LIB ORLEANS

SEPTEMBRE 18TH 2025 | 13521

Response to Comments - Pre-Consultation Meeting Feedback

Response to UDRP Comments, October 3th, 2025

2.4 PUBLIC REALM

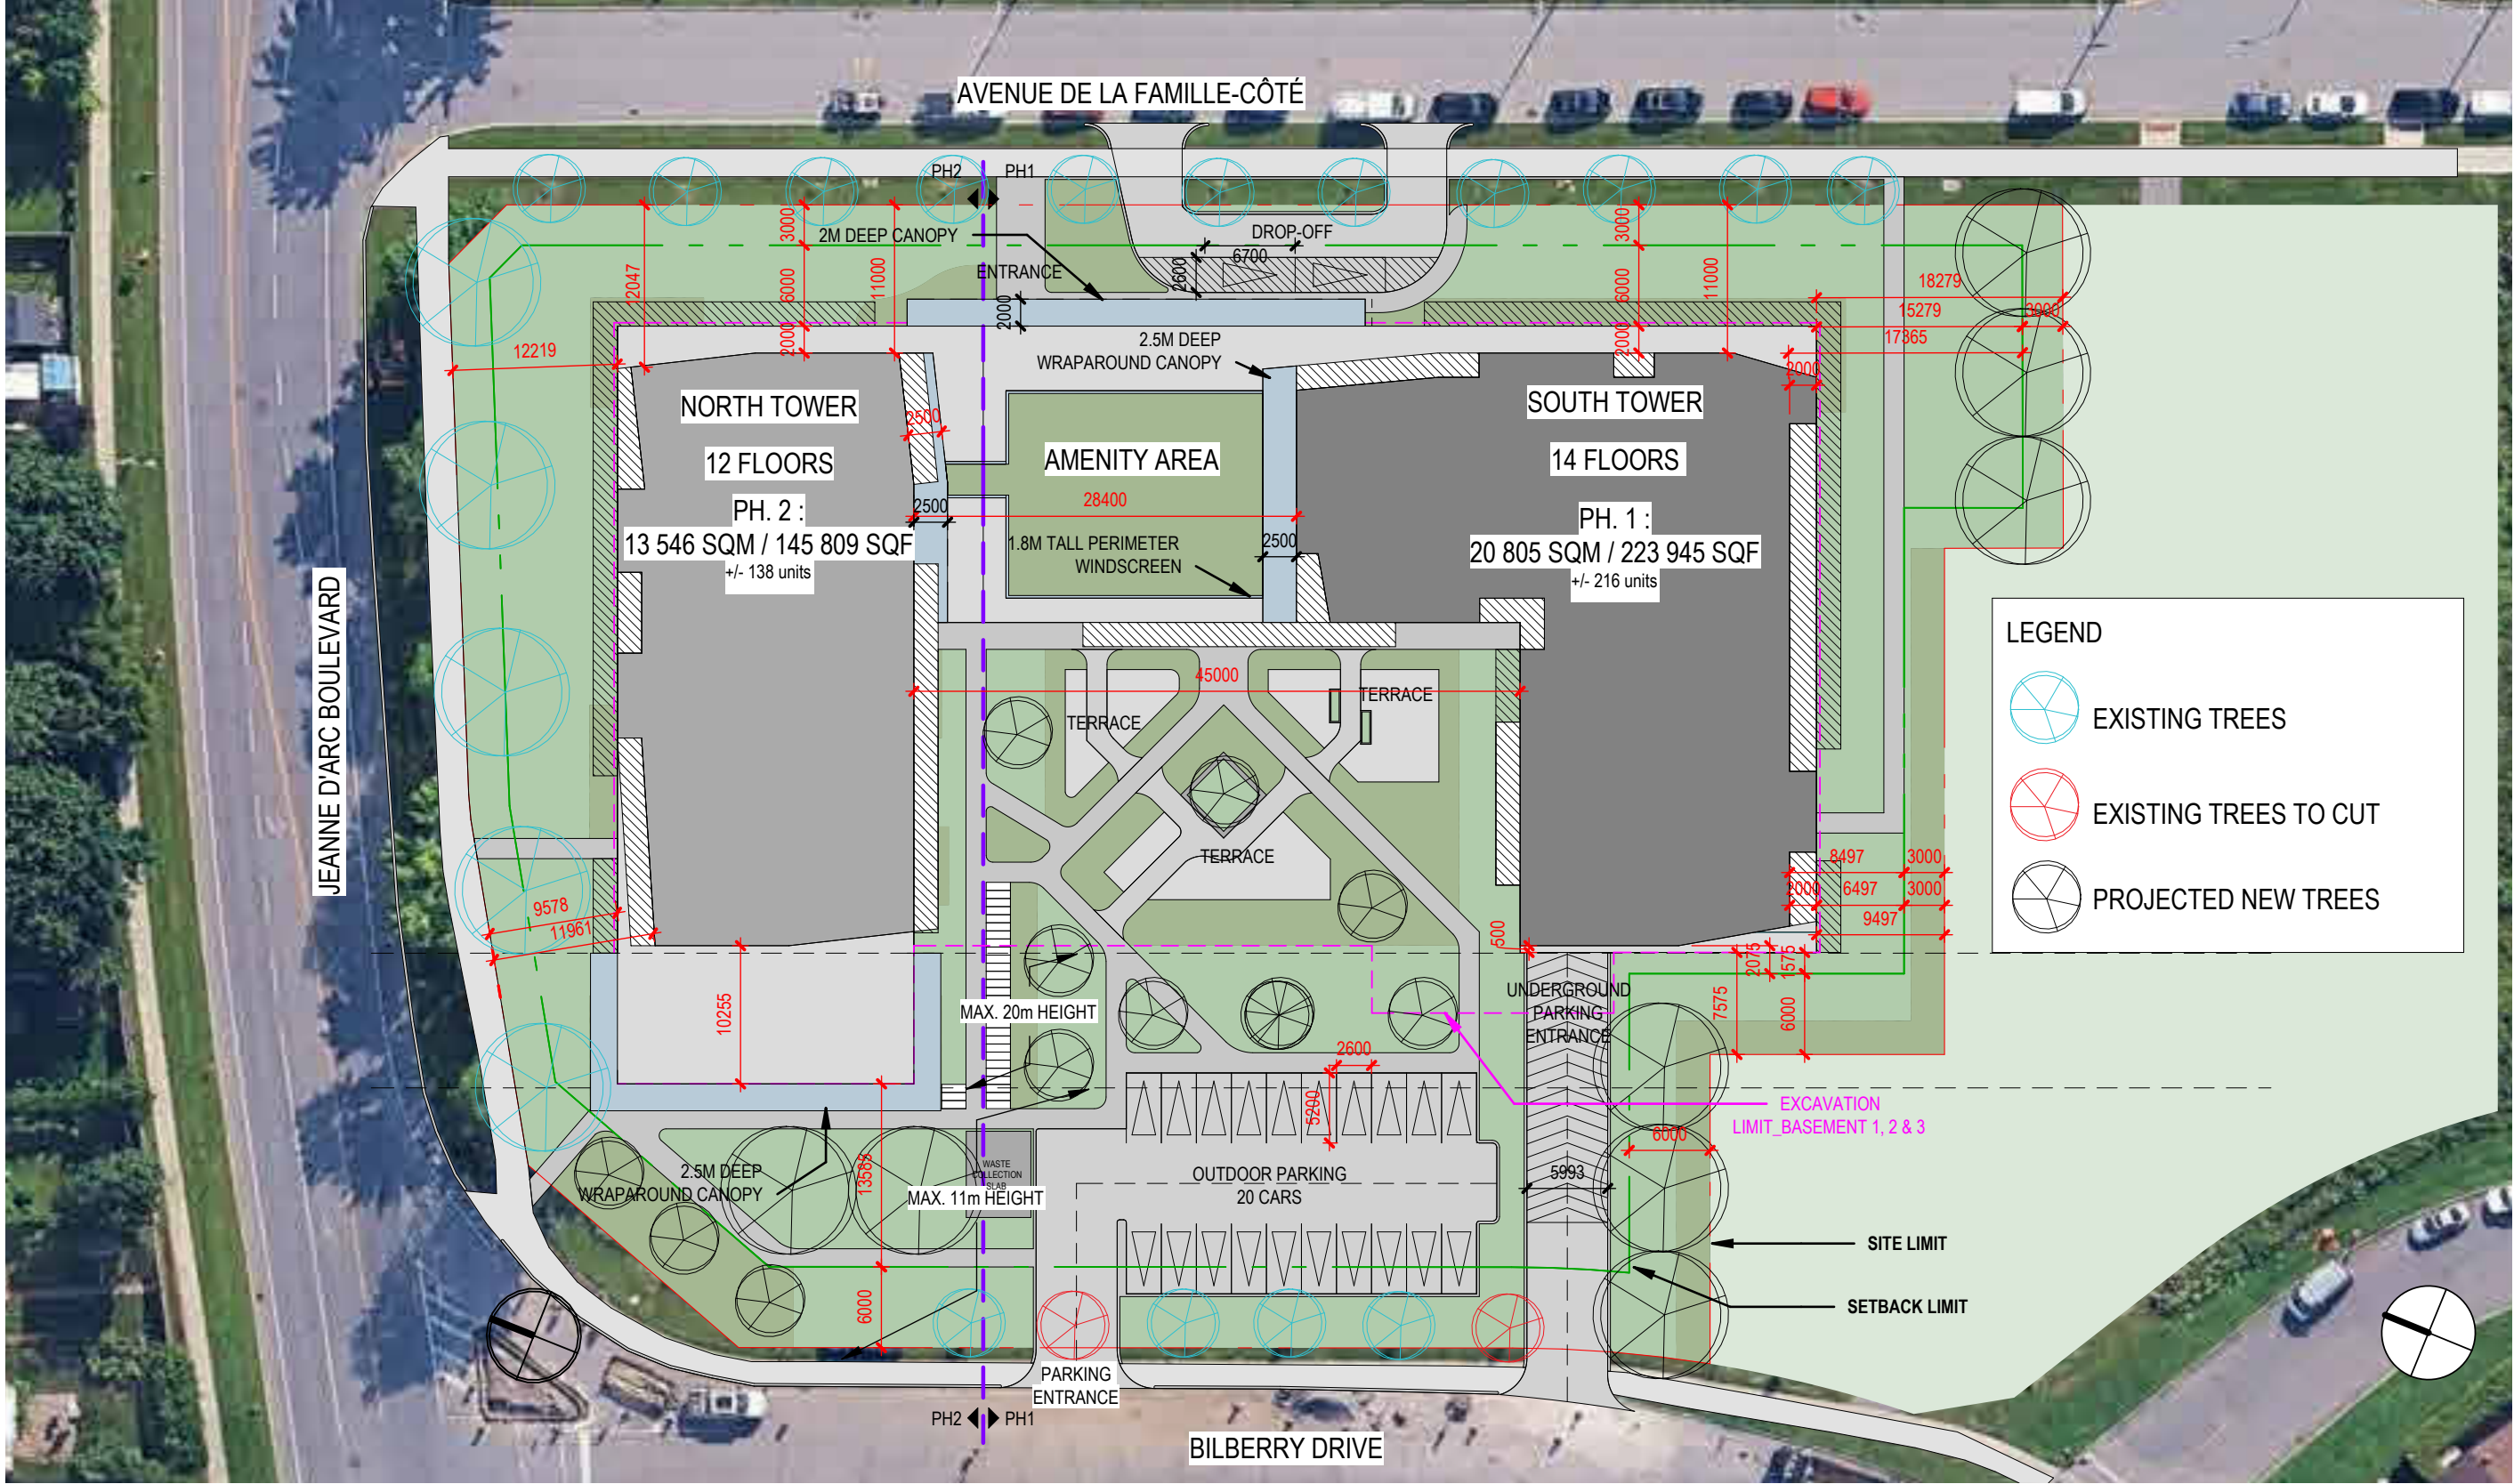
8.	The Panel recommends a continuous walking loop around the development should be incorporated into the plans for residents.	A continuous pedestrian loop has been incorporated into the site design.
